RE: Port Phoenix Water Way Marina – DCI2023-00054 – Major PD

Please find below responses and commentary to the provided comments from staff in your February 12, 2024 letter regarding the Commercial Planned Development application for Port Phoenix Water Way Marina (DCI2021-00054).

MASTER CONCEPT PLAN
FOR
PORT PHOENIX
SAFE HARBOR MARINAS
LEE COUNTY, FLORIDA

OPEN SPACE EXHIBIT
FOR
WATERWAY MARINA
SAFE HARBOR MARINAS
LEE COUNTY, FLORIDA

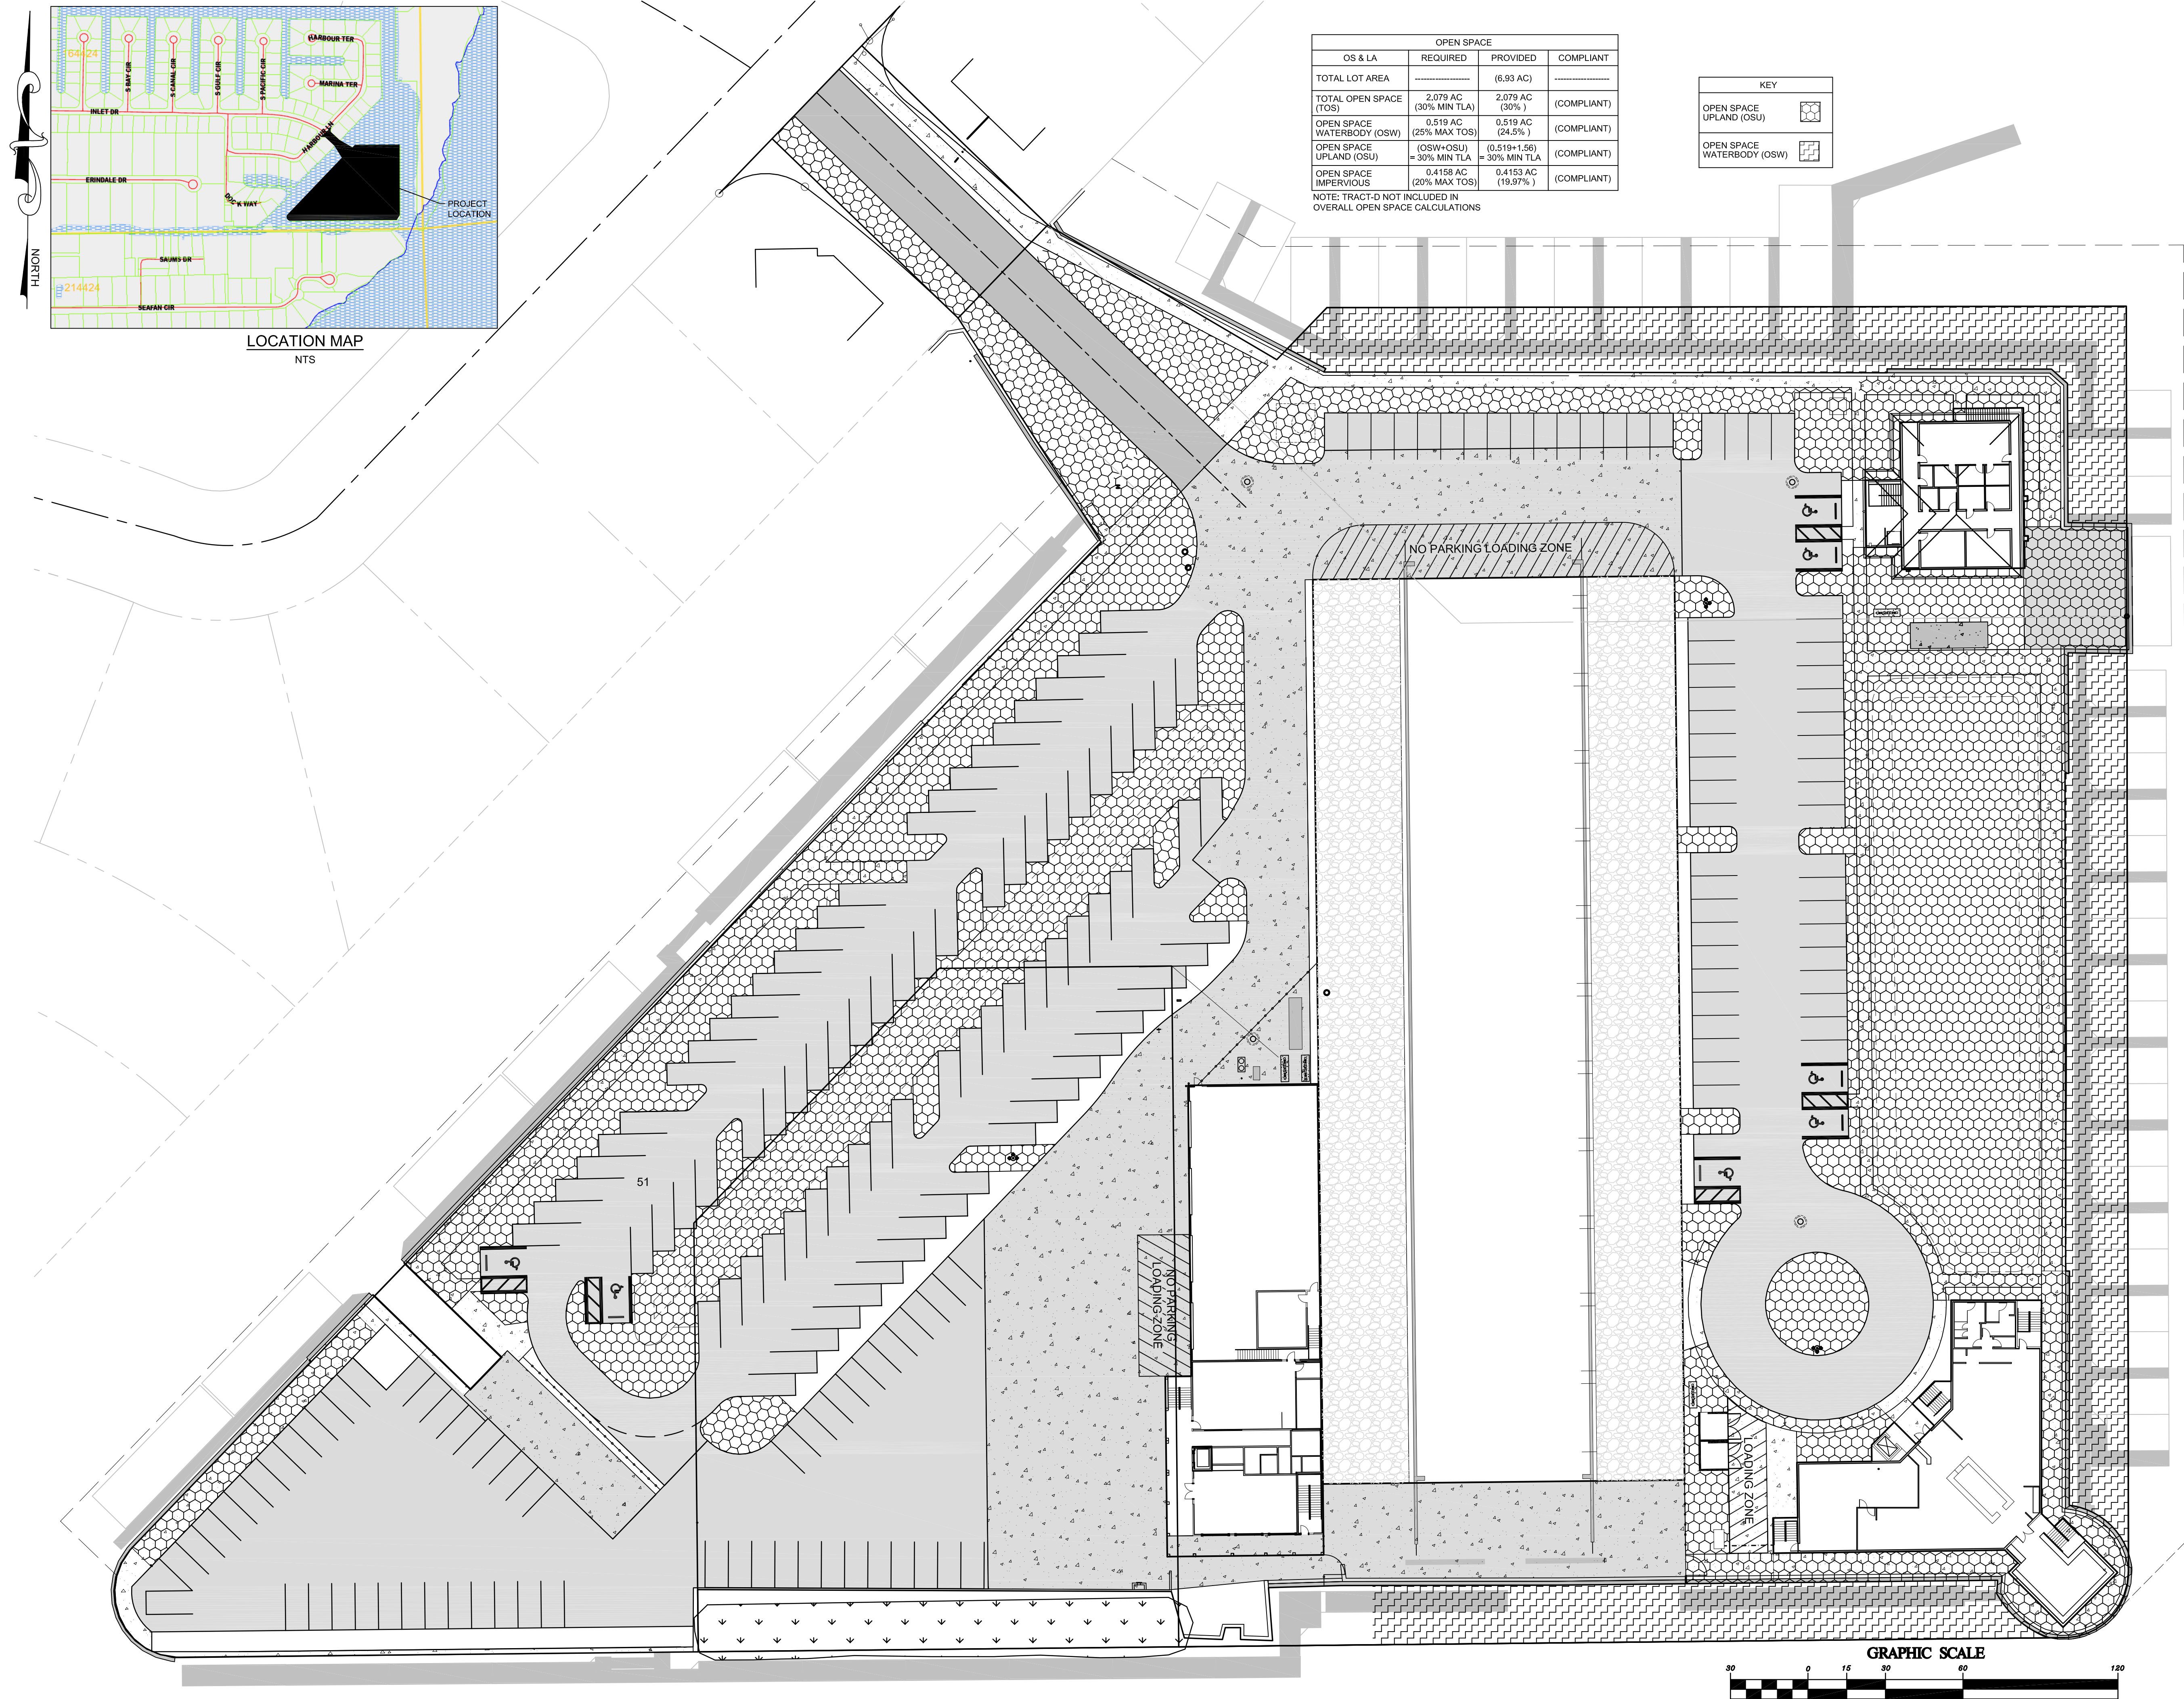
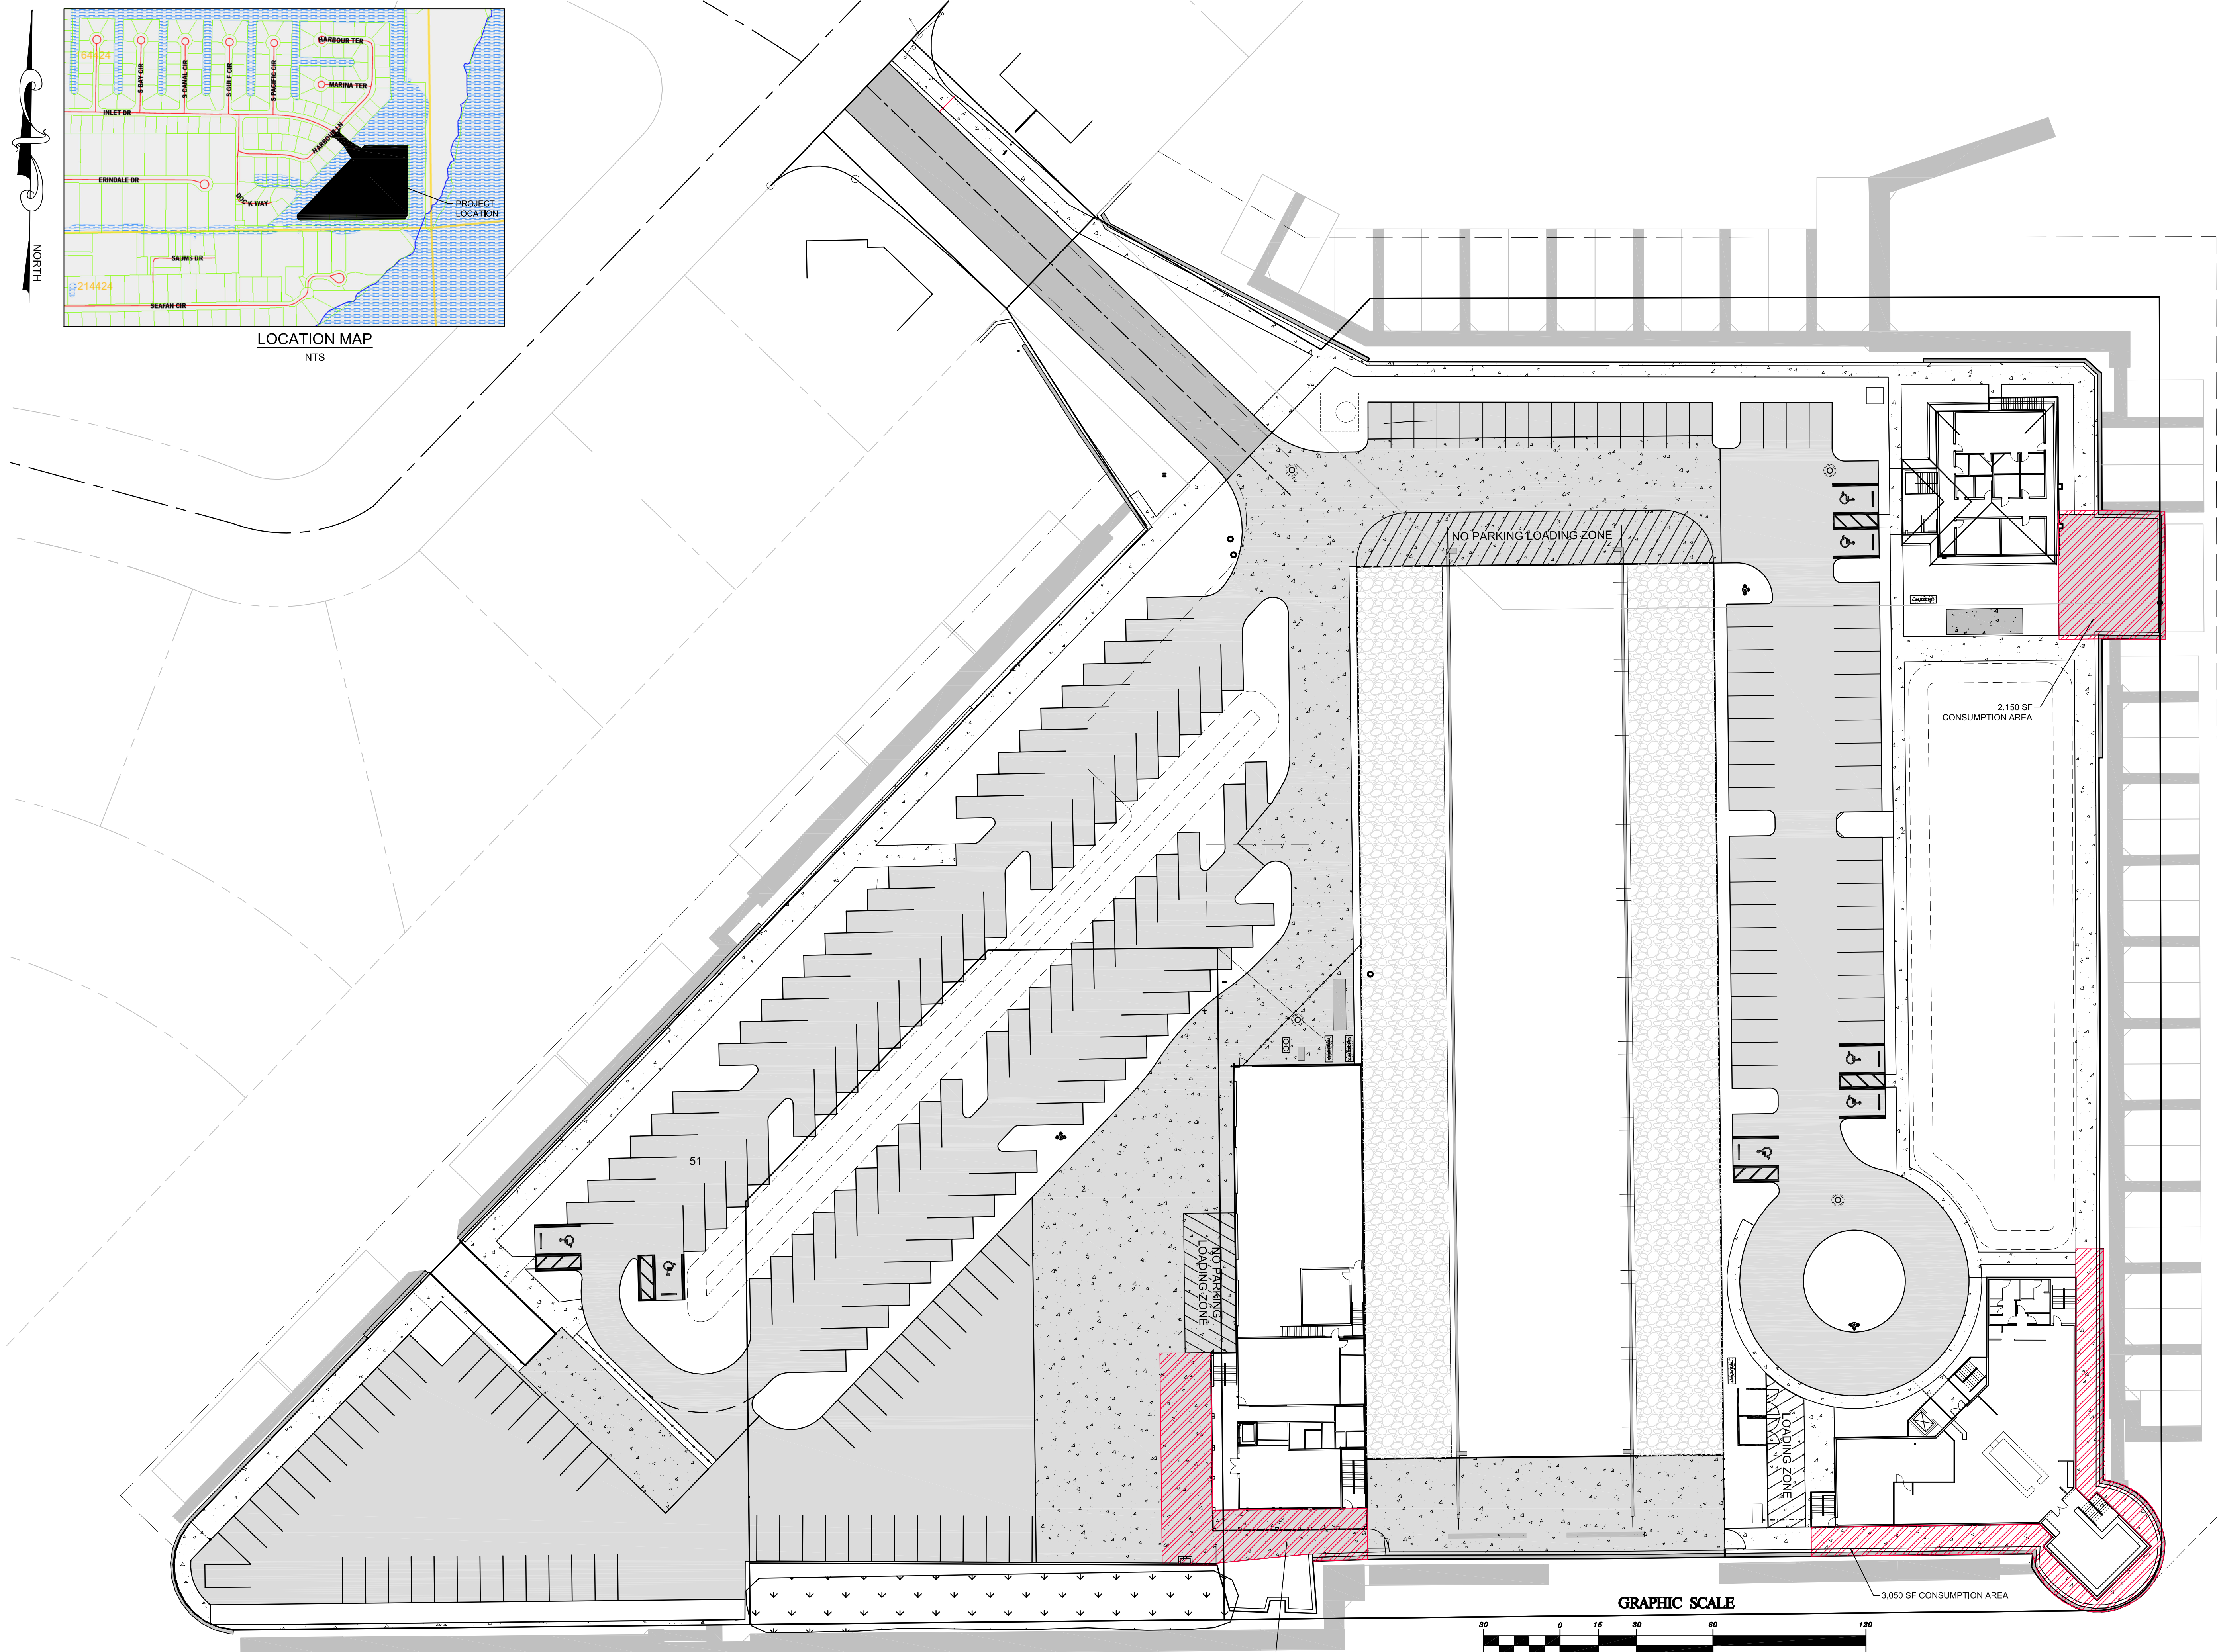
3. LDC 10-415(d) discusses the use of open space. The use of open space states that not more than 20% can be impervious. Please note that compacted limestone/shell is considered impervious per LDC 10-1. Please provide information on how the applicant will meet the open space use.

DEVIATION #7 SIDEWALK CONNECTION
FOR
WATERWAY MARINA
SAFE HARBOR MARINAS
LEE COUNTY, FLORIDA

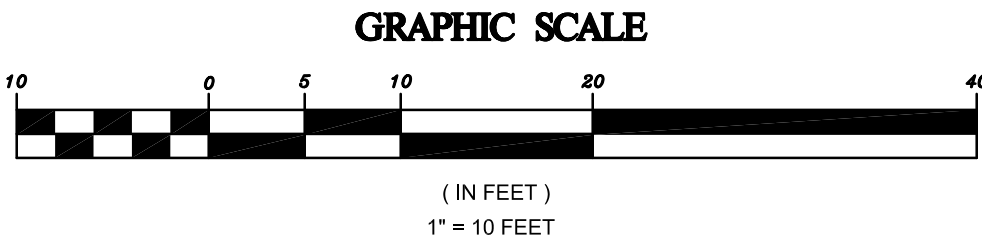
2. Deviation #7 – The applicant has requested a deviation to reduce the number of required parking spaces from 225 to 217 spaces. A decrease of approximately 3.6% is requested. Your attention is directed to LDC 34-2020(c) "Parking reduction for nonresidential uses." There are several conditions that will allow the justification of parking reduction up to a maximum of ten percent of the required total. Please provide the justification to support the requested reduction in your deviation request.

NOTE:
THIS PLAN SERVES AS A REFERENCE TO DEVIATION #7 IN REQUEST TO DEVIATE FROM SECTION 34-2020 REQUIRING A TOTAL OF 223 SPACES BE PROVIDED ON SITE

COMMENTARY: THE INTENT IS TO REQUEST A DEVIATION FROM THE OUTLINED REQUIREMENT OF 223 PARKING SPACES TO BE PROVIDED FOR THE OVERALL SITE. THE MCP DELINEATES A TOTAL OF 214 SPACES WITH 158 STANDARD AND 56 NON STACKED VALET WE ARE REQUESTING RELIEF FOR THE ADDITIONAL 11 SPACES THAT ARE DEFICIENT WITH THE CURRENT SITE DESIGN. ACCORDING TO SECTION 34-2020 (C) MINIMUM REQUIRED PARKING MAY BE REDUCED UP TO 5 PERCENT IF THERE IS A SIDEWALK CONNECTION TO THE BIKEWAYS/WALKWAYS FACILITY PLAN- PLANNED FACILITIES AND EXISTING FACILITIES. MAP 30 OF THE LEE PLAN. WE HAVE REVIEWED THIS COUNTY MAP AND COMPARED GIS IMAGERY OF THE EXISTING PEDESTRIAN WALKWAY CONNECTION TO THE SPACES. THE CONNECTION STARTS FROM BIRKDALE AVENUE HEADING EAST TO ORANGE GROVE BLVD NORTH WHERE THE INLET DRIVE PEDESTRIAN WALKWAY CONNECTS PERPENDICULAR AND WILL ROUTE PEDESTRIAN TRAFFIC TO THE SITE, AS A PART OF THIS SUBMITTAL, WE HAVE ATTACHED A SCHEMATIC DELINEATING PEDESTRIAN TRAFFIC NAVIGATION TO THE PROPOSED SITE. ADDITIONALLY 12 BIKE RACKS WILL BE PROVIDED ON SITE IN ACCORDANCE WITH SECTION 10-610(E)(3) WHERE THIS PROVIDED NUMBER OF RACKS WILL AMOUNT TO 5% OF THE TOTAL REQUIRED PARKING.

Fuel Dock Configuration:

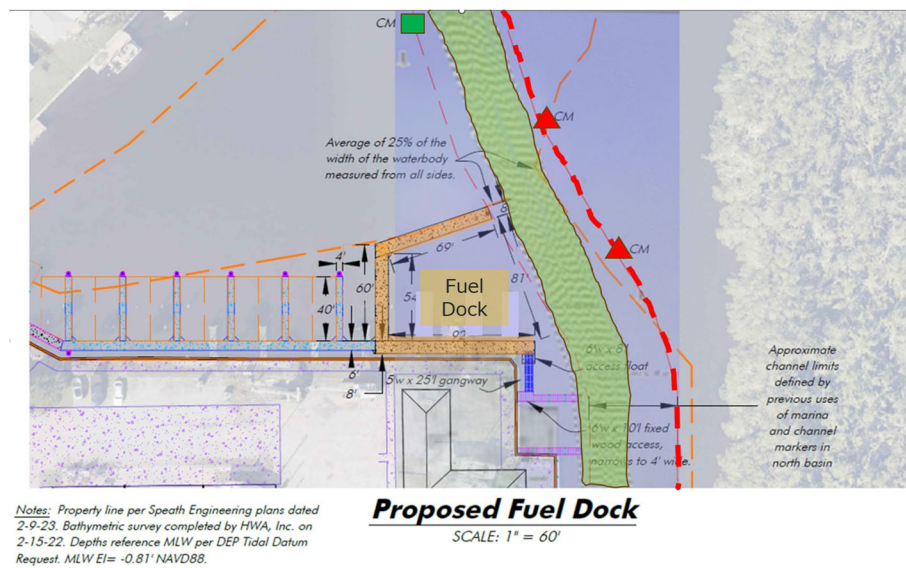
Concern:

There was significant concern expressed over initial plans for the fuel dock which indicated a possible constriction of vessel passage at a "tight" spot in the channel in the north basin.

The community expressed satisfaction with the revised plan in both meetings 2 & 3.

Light Buffering:

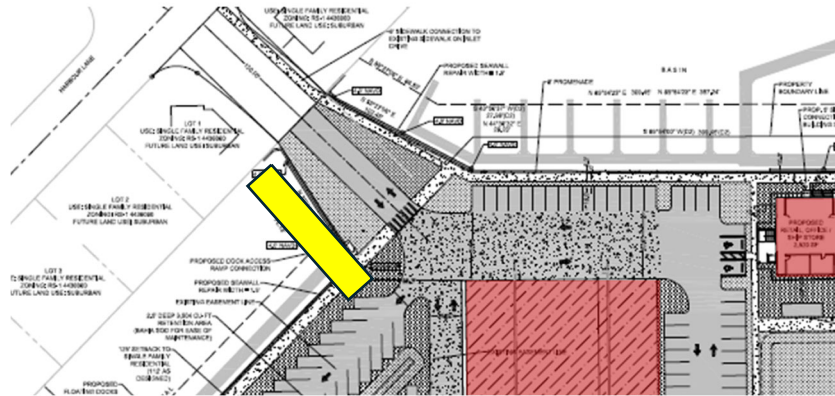
- There were specific concerns raised by residents across the western canal regarding lights (both headlights and site lights) shining in their direction at night.
- At the 2nd meeting the neighbor on the south of the access drive expressed specific concern about headlights when exiting the site.
